TECHNICAL DATA NOTEBOOK:

Letter of Map Revision For the Kemper Property APN 505-47-164C

Portion of South Branch Casandro Wash RM 0.720 to 0.924

September 2011

Kemper LOMR Plan: Without Culvert Model 2/7/2012
 River = Casandro Wash Reach = South Branch RS = 0.924

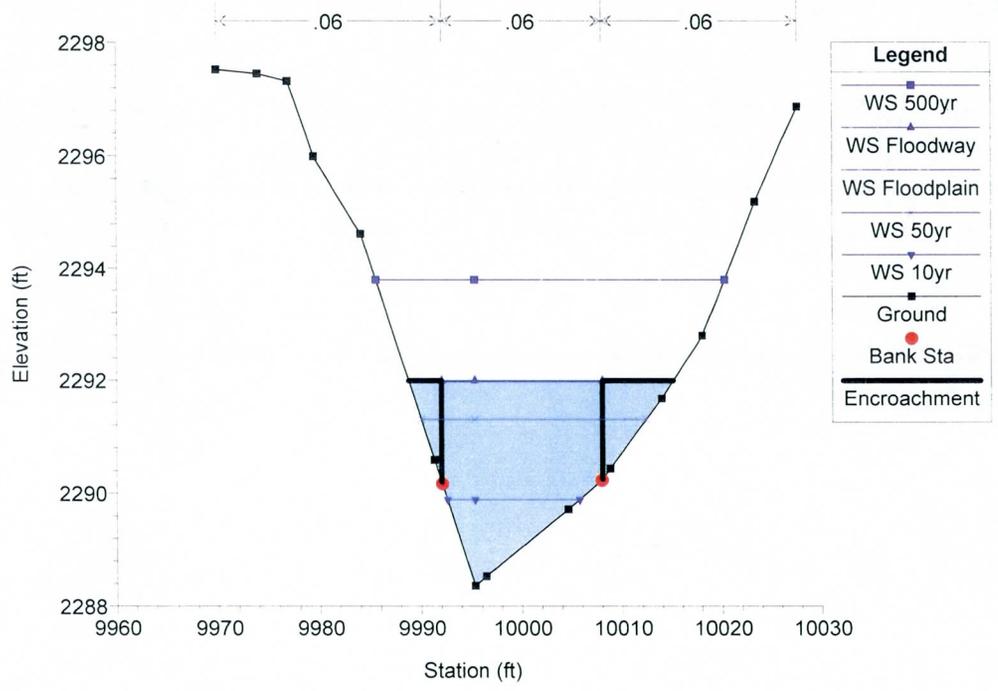
2. The floodway encroachment for .924 needs to be modified slightly. Presently it has a negative surcharge.

JEF RESPONSE: JEF has modified the floodway encroachment at .924 removing negative surcharge.

Kemper LOMR Plan: Without Culvert Model 2/7/2012
 River = Casandro Wash Reach = South Branch RS = 0.880

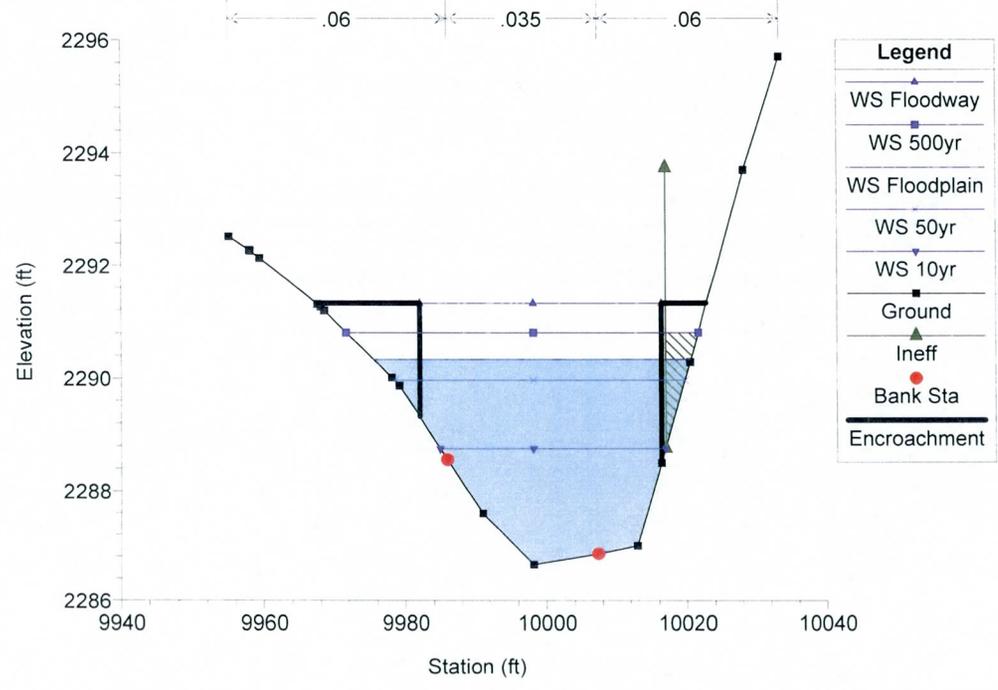
5. Ineffective flow areas. Please add an ineffective flow area for the right side of cross-section .881.

JE FULLER RESPONSE: An ineffective area has been added to the cross-section 0.880.

Kemper LOMR Plan: Without Culvert Model 2/7/2012
 River = Casandro Wash Reach = South Branch RS = 0.840

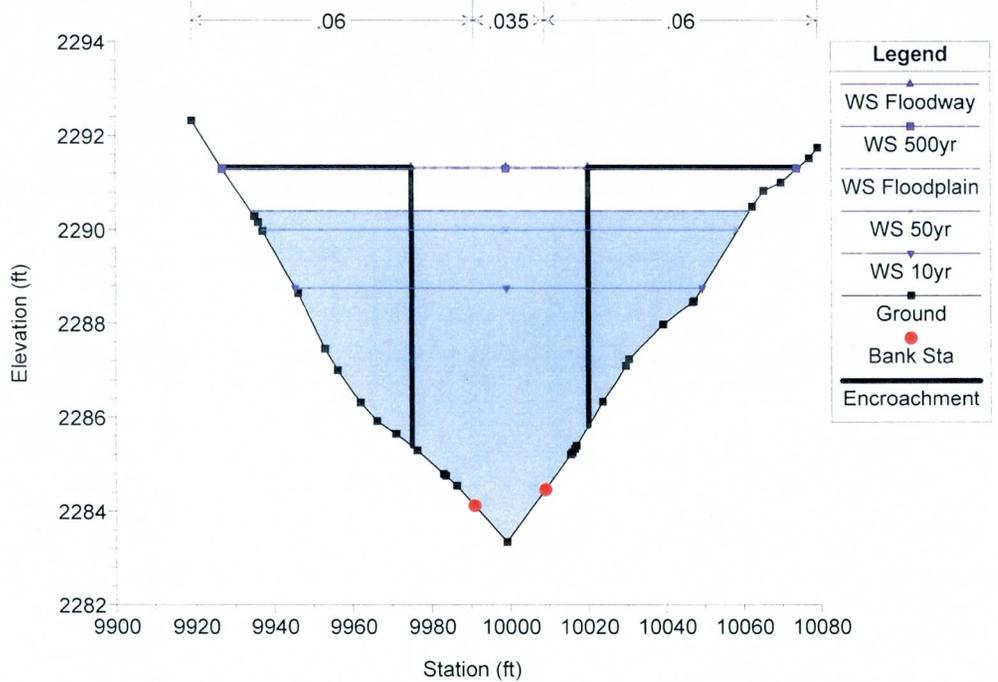
5. Floodway. For certain cross-sections the floodway stationing shown in the model does not match the limits for the floodway, please verify/update the floodplain delineation for the following cross-sections: .730 (floodway limit is beyond delineated floodplain), .744, .811, .817, .829, .840, and .893.

JE FULLER RESPONSE: A check in GIS has been performed to ensure that the latest floodway delineation matches the stationing used in the model.

Kemper LOMR Plan: Without Culvert Model 2/7/2012
 River = Casandro Wash Reach = South Branch RS = 0.821

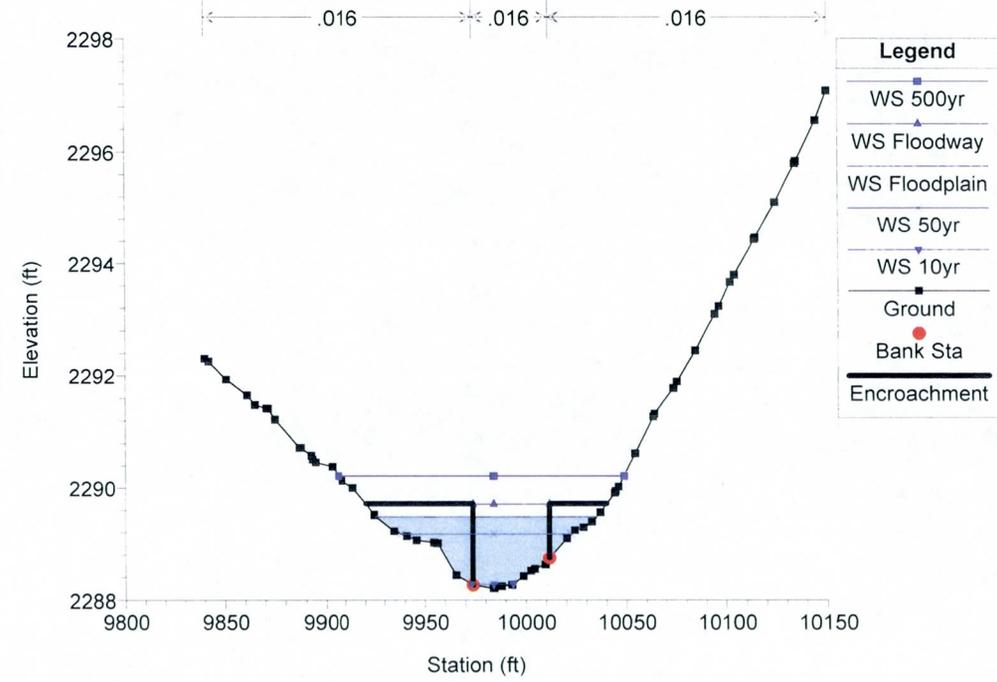
1. Delineation. For certain cross-sections the water surface stationing shown in the model does not match the limits for the delineation, please verify/update the floodplain delineation for the following cross-sections: .893, .821, .817, .744.

JE FULLER RESPONSE: The floodplain has been re-delineated as part of modifications to the HECRAS model based on the reviewer comments. A check was performed to ensure a match between water surface stationing and the floodplain delineation.

Kemper LOMR Plan: Without Culvert Model 2/7/2012
 River = Casandro Wash Reach = South Branch RS = 0.773

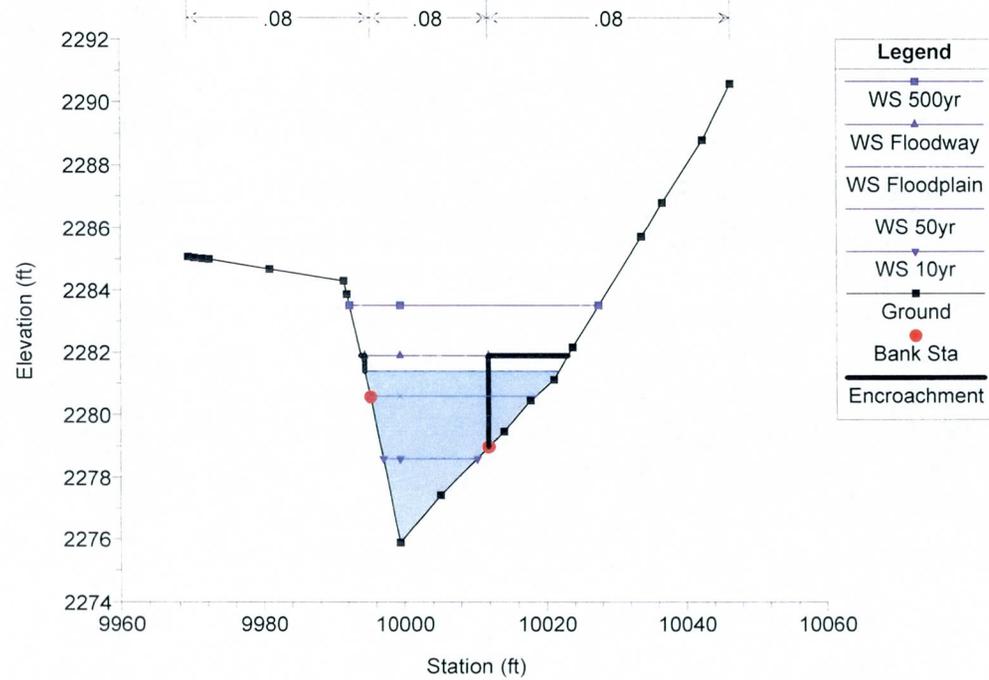
2. Bank stations. Different bank stations are used for the following cross-sections between the with culvert geometry file and the without culvert geometry file. Please correct.
 - .893, .829, .773, and .730 (slightly off)

JEF RESPONSE: Bank stations have been fixed.
